Rezoning Transportation Analysis

Petition Number: 2020-066

General Location Identifier: Tax ID 21313828

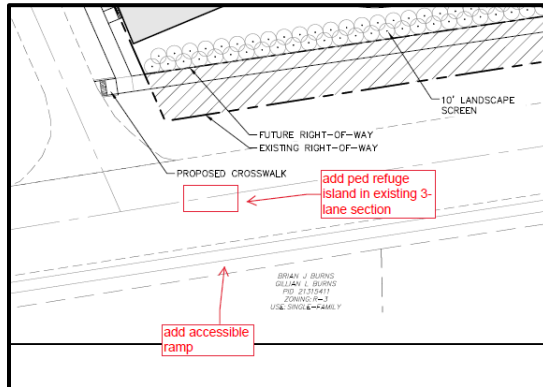
Please provide responses to our comments.

5. The petitioner should revise the site plan and conditional note (s) to state that the Petitioner agrees to pay in lieu or to install a pedestrian hybrid beacon (PHB) at the pedestrian crossing described in comment 4. Traffic volumes and speeds on this part of Sardis Rd. North are high enough that a pedestrian refuge island alone is insufficient. (Revised 08/25/2020)
6. ~~**Resolved** Sample format for comment that is resolved~~
